Consumers  
Power  
Company

Re: Docket 50-155  
License DPR-6  
Errata - To Pro-  
posed Tech Spec-  
ification No 31

Jersey Nuclear Company  
 FUEL BUNDLE SCHEMATIC  
 BIG ROCK POINT  
 RELOAD-G  
 JN-300,667

FIGURE 5.8

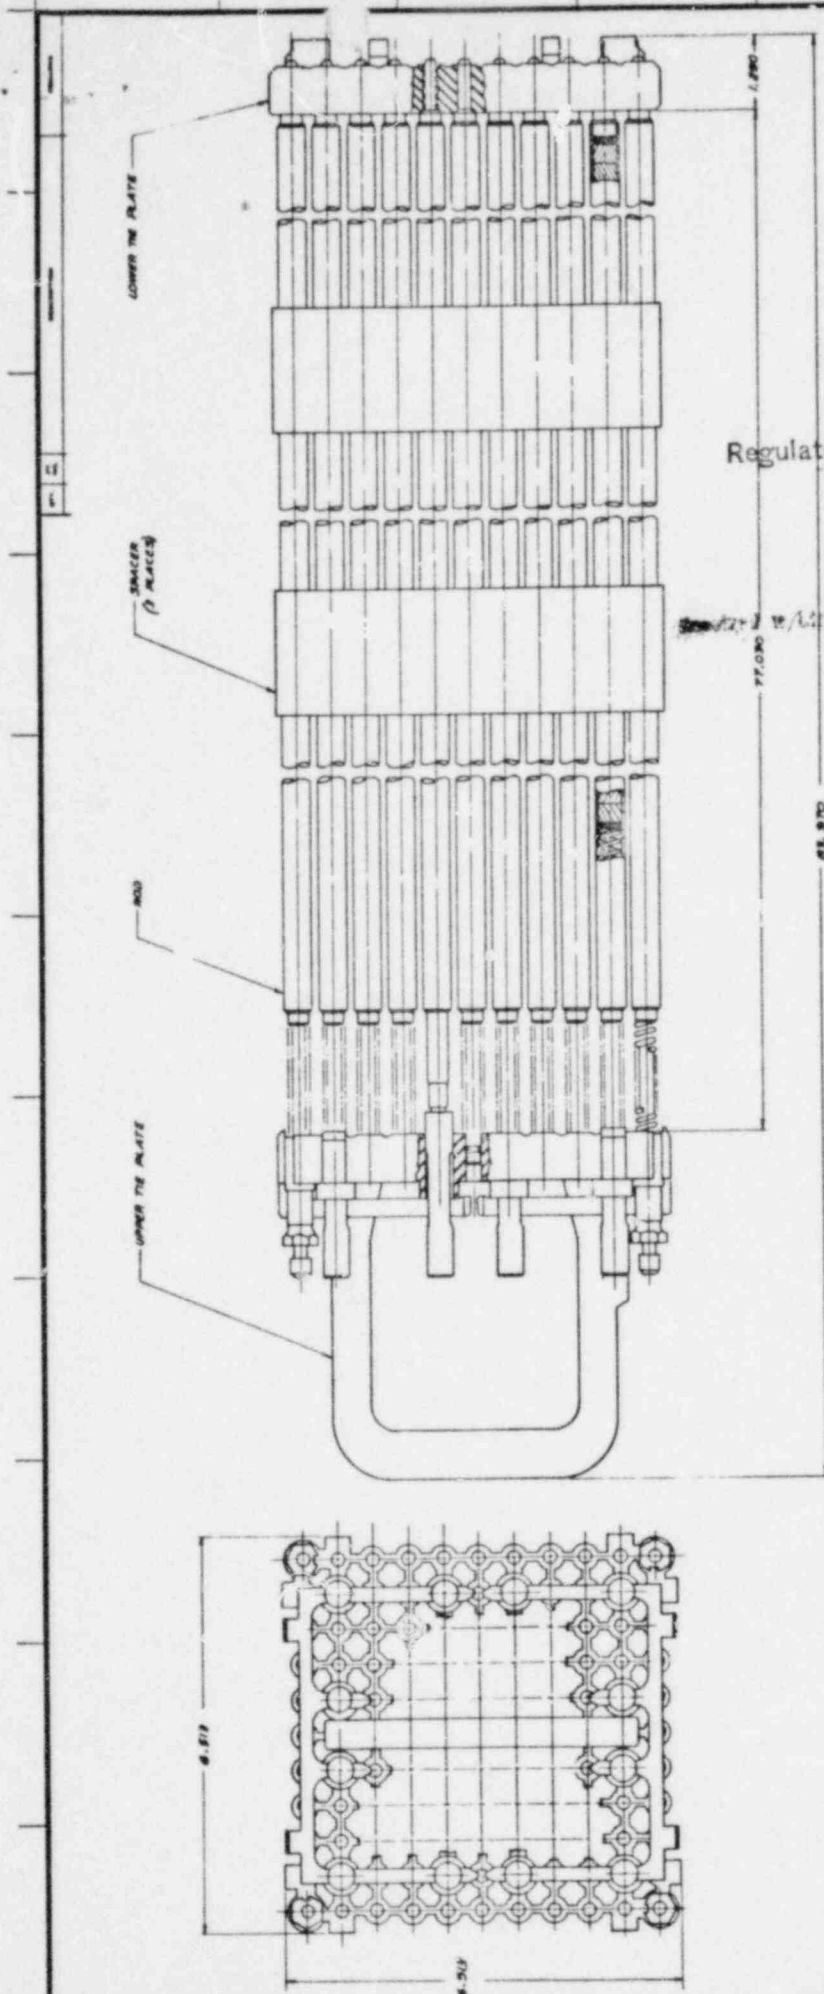
Please substitute the attached Drawing No 5.8 for the one submitted in our Request for Technical Specification Change No 31 dated June 16, 1972. Also, please accept our apology for the wrong salutation on the same letter - it should have read "Dear Mr. O'Leary" and not "Dear Mr. Bloch."

- 6-27-72
- ROD TYPE C - COBALT
  - ROD TYPE L - 2.3 W/O ENRICHED U-235
  - ROD TYPE M - 3.2 W/O ENRICHED U-235
  - ROD TYPE H - 4.6 W/O ENRICHED U-235
  - ROD TYPE P - 5.0 W/O FISSIONABLE PU + U
  - ROD TYPE X - UNFUELED Zr
  - ROD TYPE M<sub>50</sub> - 4.6 W/O ENRICHED U-235 WITH GADOLINIUM
